UNITED STATES  
NUCLEAR REGULATORY COMMISSION

SUBJECT: ISSUANCE OF AMENDMENT FOR INDIAN POINT NUCLEAR GENERATING  
UNIT NO. 3 (TAC NO. M88261)

AMENDMENT NO. 154 TO FACILITY OPERATING LICENSE NO. DPR-64-INDIAN POINT UNIT 3

SAFETY EVALUATION BY THE OFFICE OF NUCLEAR REACTOR REGULATION  
RELATED TO AMENDMENT NO. 154 TO FACILITY OPERATING LICENSE NO. DPR-64  
POWER AUTHORITY OF THE STATE OF NEW YORK  
INDIAN POINT NUCLEAR GENERATING UNIT NO. 3  
DOCKET NO. 50-286

**Figure 3.1.A-3**  
**RCS Pressure Limits for Low Temperature Operation**  
**Figure applicable to 11 EFPY**

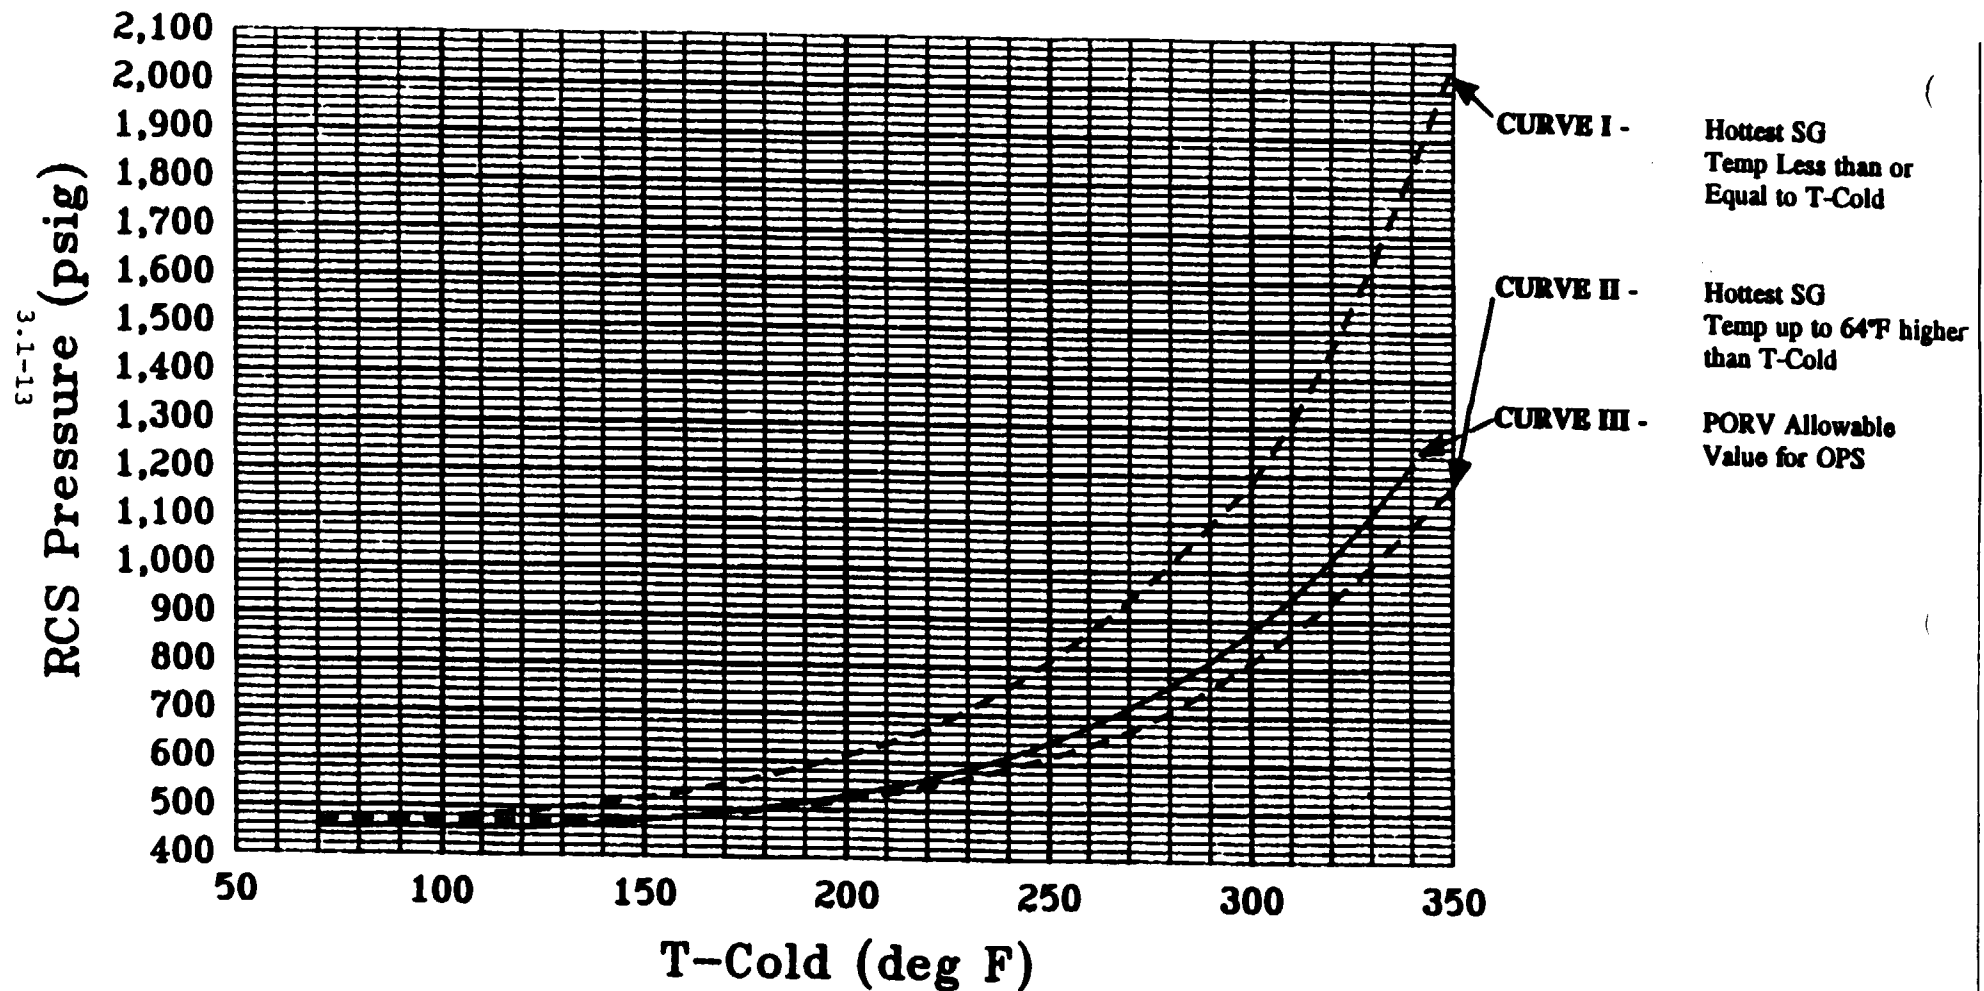
- (1) The overpressure protection system (OPS) actuation curve (TS Figure 3.1.A-3).
- (2) The minimum refueling water storage tank (RWST) water volumes and low level alarm settings (specified in TS Section 3.3.A). In addition the RWST level indicating switch calibration frequency (specified in TS Table 4.1-1) has been changed from once every 18 months to once every 6 months.
- (3) The control room ammonia and chlorine toxic gas instrument settings (specified in TS Section 3.3.H).
- (4) The containment pressure high and high-high engineered safety features instrument settings (specified in TS Table 3.5.1).
- (5) The main steam flow engineered safety features instrument settings (specified in TS Table 3.5.1).

2.1 TS Figure 3.1.A-3, Curve III, The Overpressure Protection System (OPS) Actuation Curve.

Reactor pressure vessel integrity at low temperature is protected by opening the Power Operated Relief Valves (PORVs) when the Reactor Coolant System (RCS) pressure reaches a maximum allowable pressure.

This maximum allowable pressure is not a static point but is a function of RCS temperature as shown by the OPS actuation curve. The instrument uncertainty relating to this curve is also a variable function.

Proposed change: The existing OPS actuation curve would be replaced with a new curve. In accordance with TS Section 3.1.A.8.a, this new curve would continue to be used to verify that both OPS PORVs have maximum allowed "as found" lift settings not to exceed the proposed "allowable value" which are shown on the curve. The "allowable value" shown on the existing curve does not represent the true allowable value because it does not include any dynamic margin for instrumentation uncertainties, except a fixed value relating to a temperature 10 °F and pressure 30 psi.

Evaluation: The licensee stated that the proposed new TS curve for "maximum OPS trip setpoint" is based on the loop accuracy calculation for automatic circuitry, and ascertains that the setpoint at any given RCS temperature includes adequate margin to incorporate the instrument uncertainty for that particular point. The new curves are based on a Combustion Engineering (CE) document, MISC-MPS-ER-005, "Pressure-Temperature Limits for IP3," and were drawn according to the following steps.

- A. The proposed "analytical OPS limit curve" was drawn by raising each temperature value from the CE document by 50 °F, and reducing each associated pressure value by 70 psi. Raising the temperature was done to compensate for the thermal lag and the pressure was lowered to protect against the design basis pressure overshoot, and to compensate for the response time of the instrument loop and PORVs.

- B. On the proposed analytical OPS limit curve, temperature points spaced 10 °F apart were chosen and for each point the total loop uncertainty including drift was calculated. The resulting uncertainties were then converted to an equivalent pressure value. The maximum OPS trip setpoint for each selected temperature point was calculated by subtracting the pressure equivalent of the total loop uncertainty from its analytical value at that point, and all these points were joined by a smooth curve which was the new proposed curve for "maximum OPS trip setpoint."

- C. For each temperature point on the proposed analytical OPS limit curve, the "maximum allowable OPS pressure" was computed by adding a pressure equivalent of the drift to the pressure equivalent of the setpoint, and all calculated points were joined by a smooth curve.

The new curves are slightly less restrictive as compared to the existing curves, but the licensee's submittal states that the allowance determined by the revised loop accuracy calculation satisfy the assumptions made in the safety analysis. Because the new OPS curve accounts for loop uncertainty and also satisfies all assumptions and bases of the existing safety evaluation, it is acceptable to the NRC staff.
